Environmental Planning Commission

Staff Report

Agenda Item Number: 1
Project #: 2023-008619
Case #: SI-2023-00871
Hearing Date: November 16, 2023

Agent	Consensus Planning
Applicant	Jason Skarsgard
Request	Site Plan-EPC
Legal Description	Tract A-2, Block 2 Mandell Addition No. 2 (Replat of Tract A block 2) and the East 50-feet of Lot 4, Block 2, Mandell Addition No. 2 (Amended & Supplemental plat of Blocks 2, 3, 6, 7, 10 & 11)
Location	Northeast corner of Menaul Blvd and 2nd St. NW
Size	Approximately 1 acre
Zoning	MX-M

A1 TRAFFIC CONTROL LAYOUT
1" = 20'

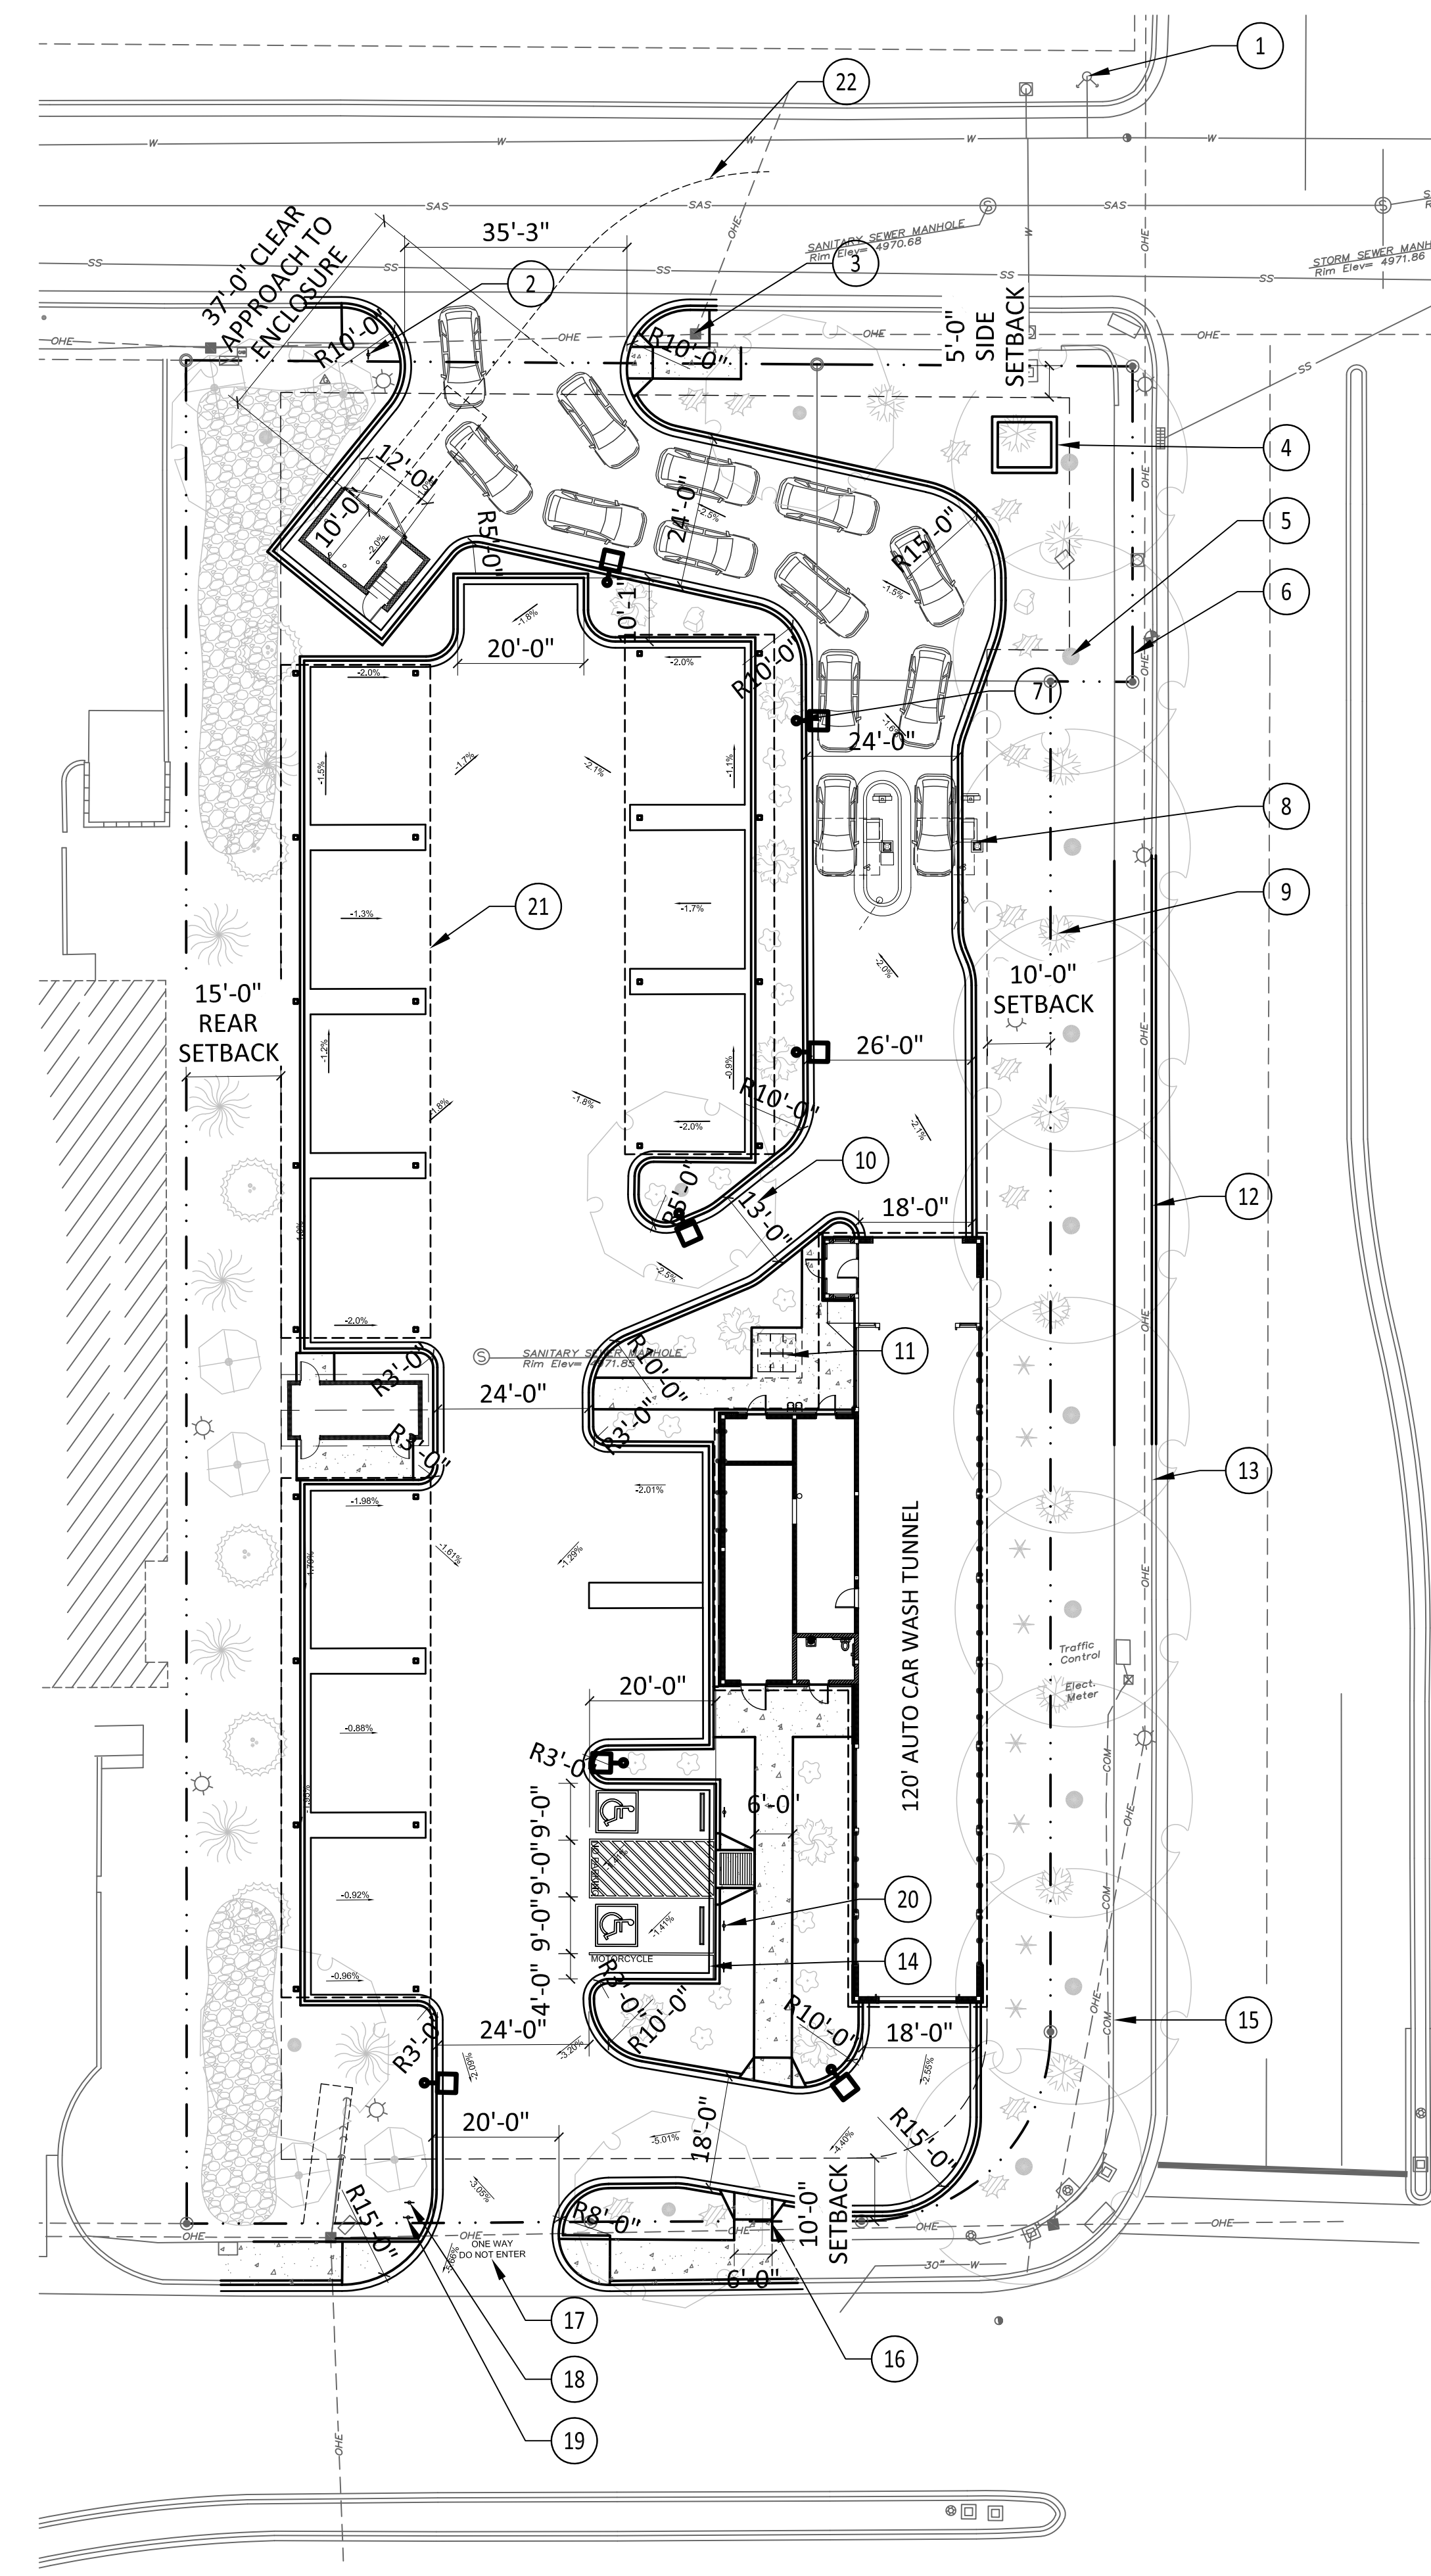
4. Please use engineering scale units. Site plan uses architectural scale units (1/16” = 1’0”) instead of using a required engineering scale unit.
5. A lot of the information required on the Site Plan could be copied from sheet AS101. – the TCL.
